A check of the plans filed with the application for permit for construction of a single family dwelling house and attached garage on Lot 12 Brookside Road raises a number of questions concerning certain details of framing about which more information is needed before a permit can be issued. Details in question are as follows:-

Building permit for construction of a single family dwelling and attached garage
on Lot 12 Brookside Road is issued herewith based on the plans originally filed with
the application for permit, but subject to the changes and additions indicated in an
addendum issued by the architect on June 11, 1953 and on the revised Sheet #6 of the
plans as filed at this office on June 16, 1953.

House for Frank Logan, Brookside Road, Portland, Maine.

Addendum
June 11, 1953

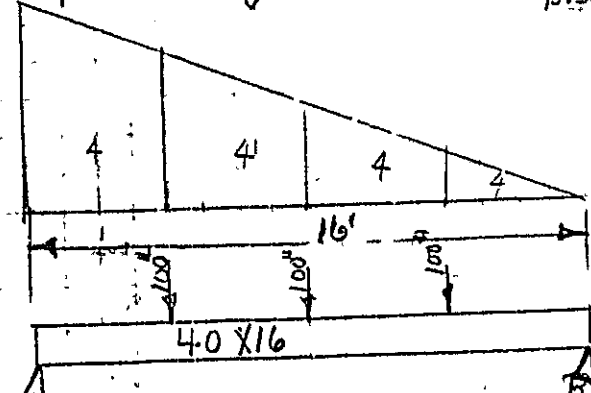
2- First Floor Framing:

Girder A: - $14 \times 12 \times 40 = 4680 \#$

Girder B: - $8.5 \times 14 \times 40 = 4760 \#$

Girder C: - $15.5 \times 11 \times 60 = 10,230 \#$

10 x 14 dressed D.T. - 11' span = 26,235 # } O.K.

2 x 10 dressed D.T. - 17' span = 1438 #

$\frac{1438}{1 \times 17} = 84 \#$ per sq. ft. - O.K.
